STAFF REPORT

CITY OF COLUMBUS PLAN COMMISSION (March 13, 2024 Meeting)

Docket No. / Project Title: CDP-2024-001 (Lillian Schmitt Elementary)
Staff: Andres M. Nieto

Applicant: Bartholomew Consolidated School Corporation
Property Size: +/- 9.05 acres
Current Zoning: P (Public/Semi-Public Facilities)
Location: 2675 California Street, in the City of Columbus.

DRAWING NUMBER
E101

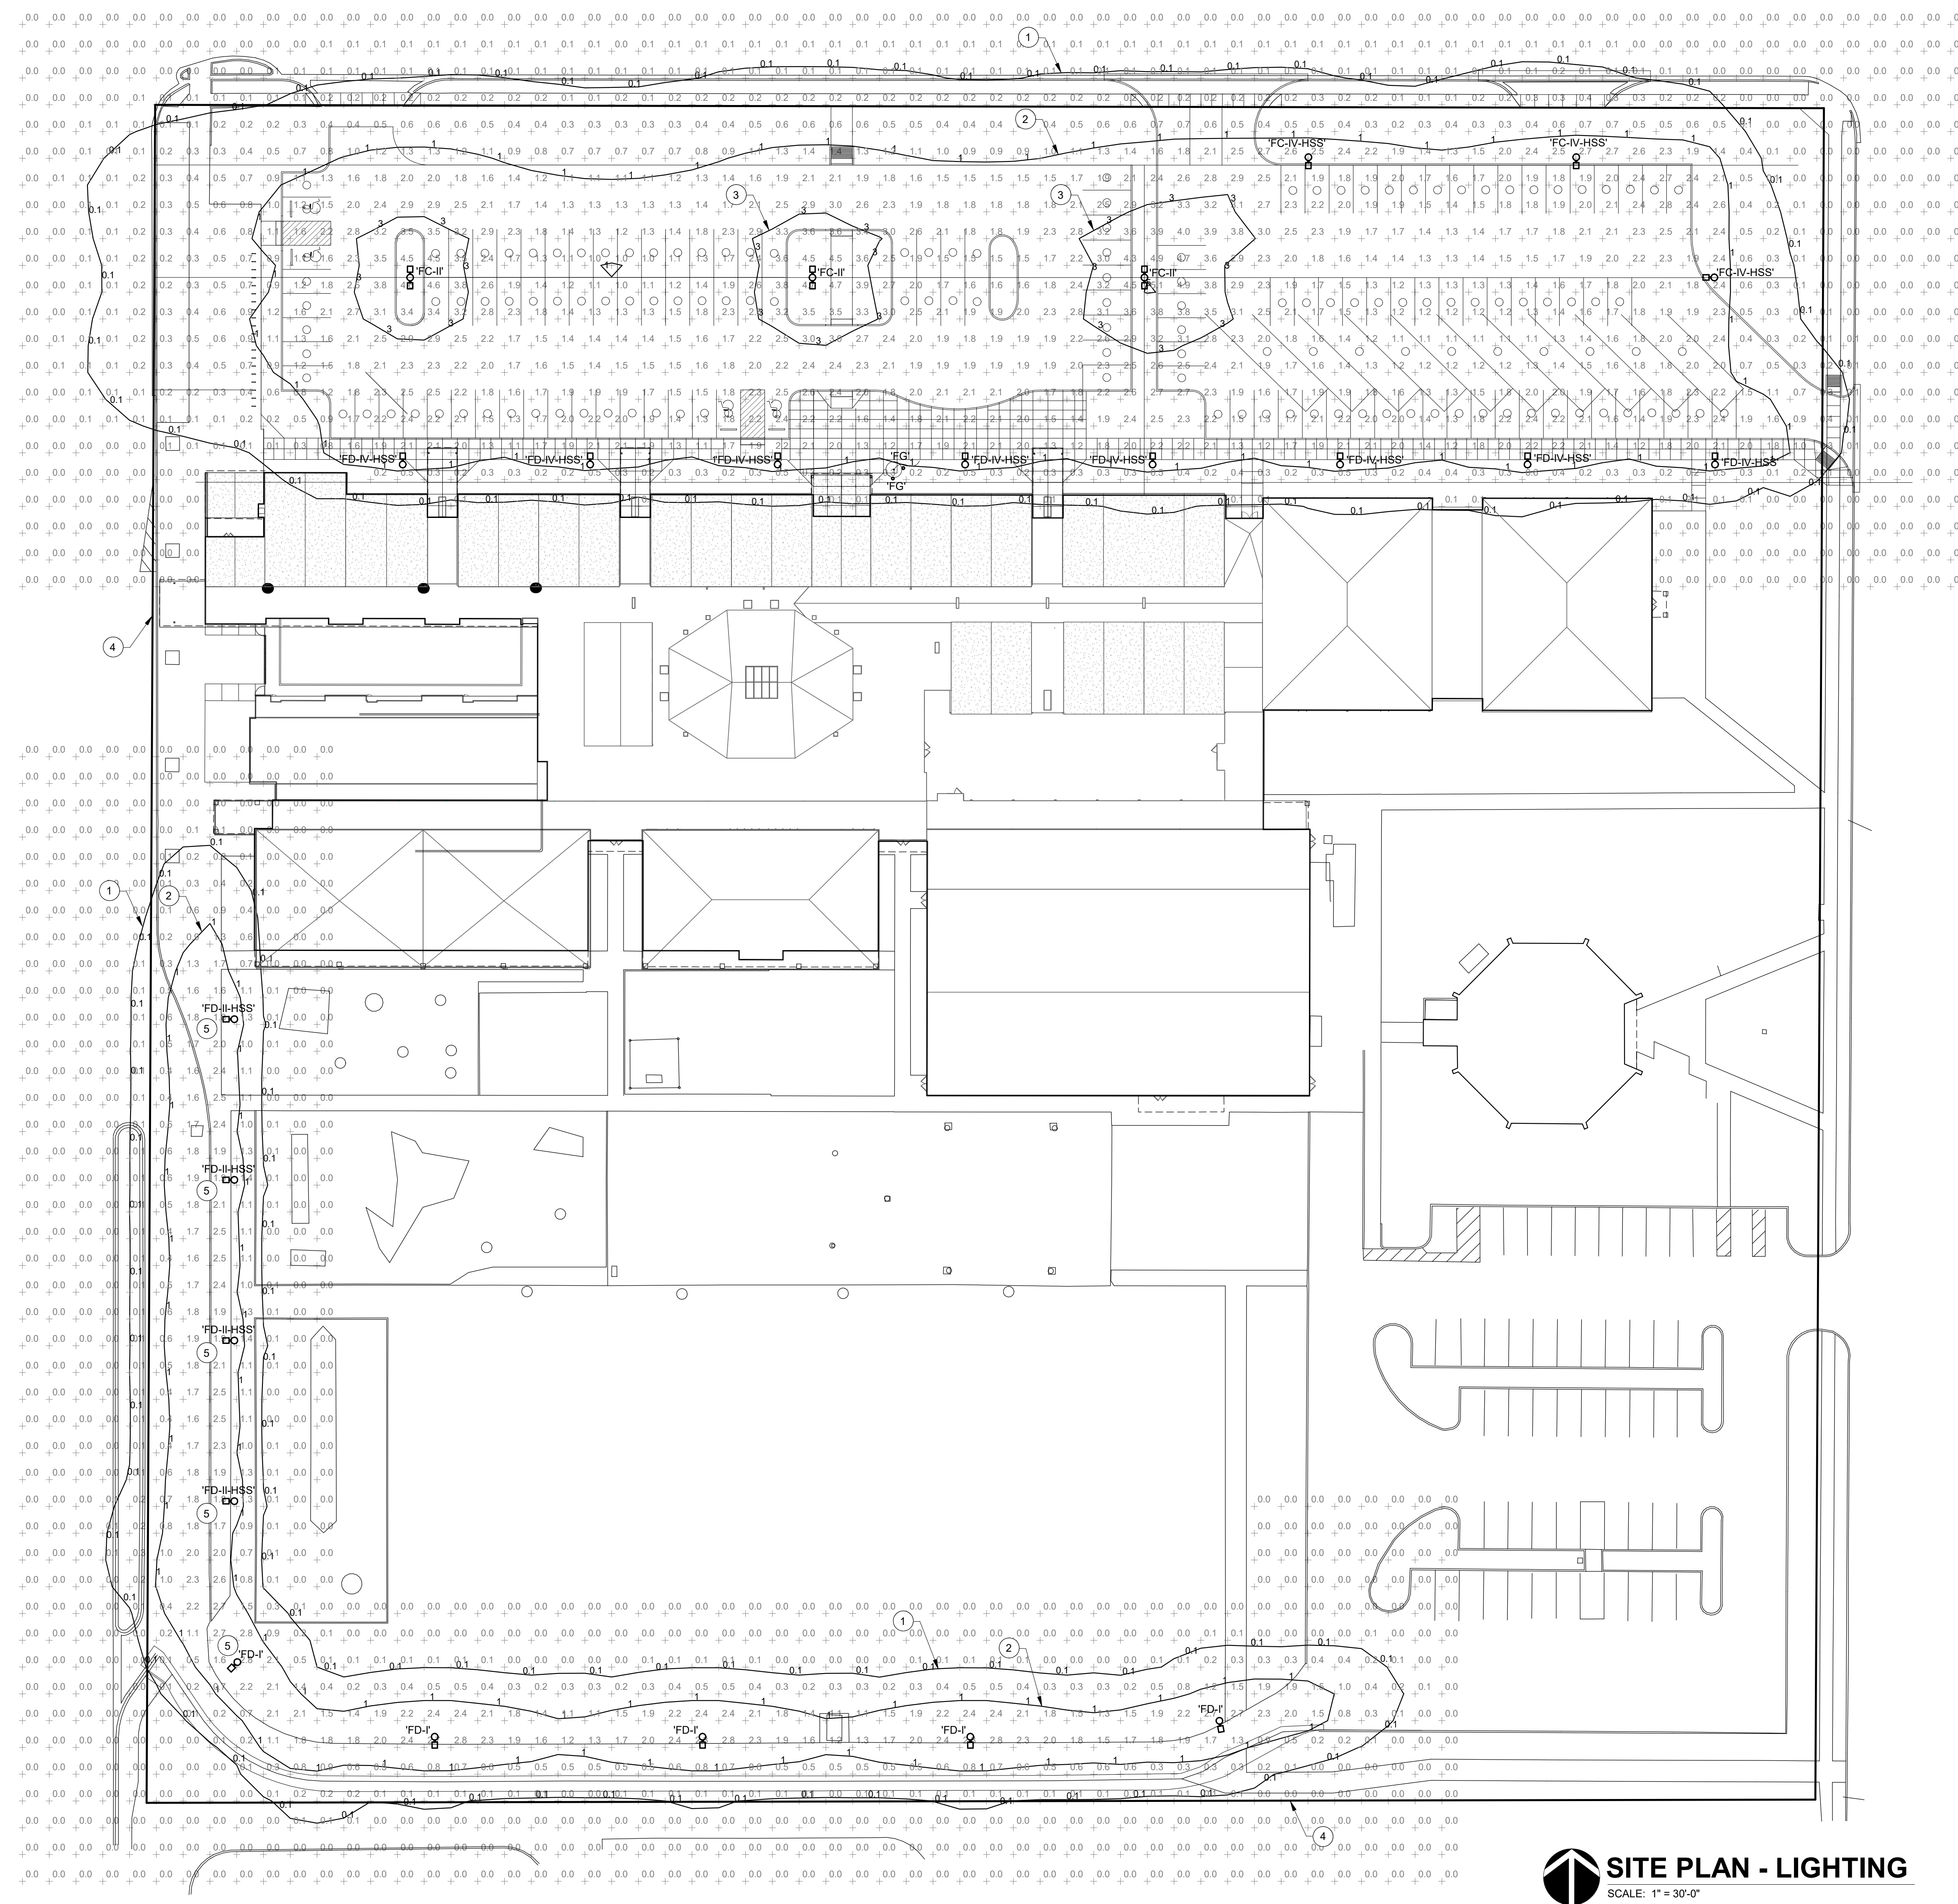
8. Proposed new light poles in parking lot islands shall be relocated outside of required landscape areas where they conflict with required landscaping.

14. New exterior lighting, which is compliant with the requirements of the zoning ordinance, is included in the applicant’s parking lot redesign. This includes 3, 25-foot tall light poles located in parking lot landscape islands, and 11, 15-foot tall light poles around the perimeter of the parking lot. There are an additional 9, 15-foot tall light poles included in the plans to be added along the western frontage (California Street) of the playground and the south side of the property. The Zoning Ordinance
